Product Change Notification

Product Change Notification: PCN-25-255229
Customer: Mouser Electronics Inc (167836) Location: Mansfield PCN Date: 18-SEP-25
Agreement: Agreement Unknown

Product Description: (Text limited to 120 characters)
PIOT

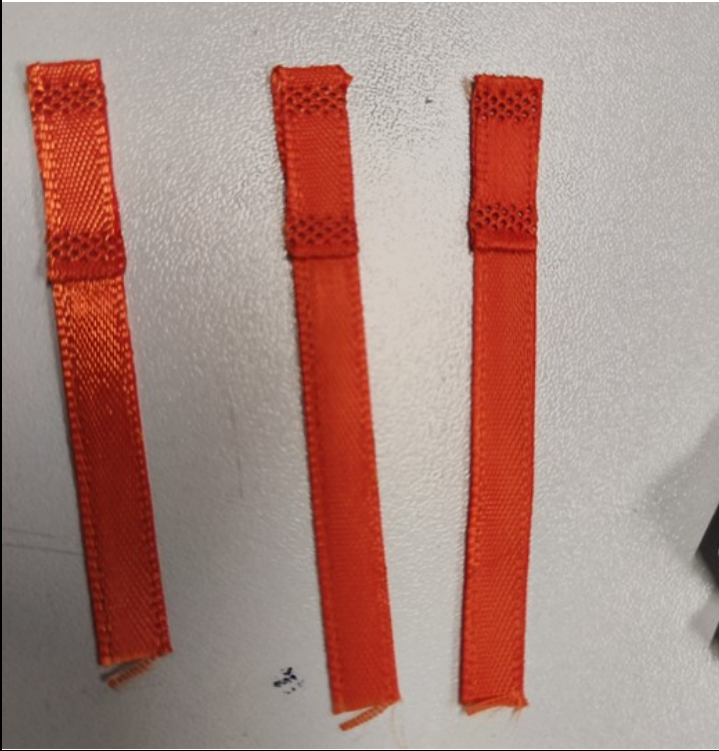
Please be aware of an upcoming cosmetic change to the listed part numbers (not affecting the function of the product). Before: Single layer polyester ribbon 0.25mm thickness
After: Single layer polyester ribbon 0.25mm thickness with stack-up ending (6 layers) bonding, the ending thicknesss will be 1.2~1.5 mm, stack-up length 22mm
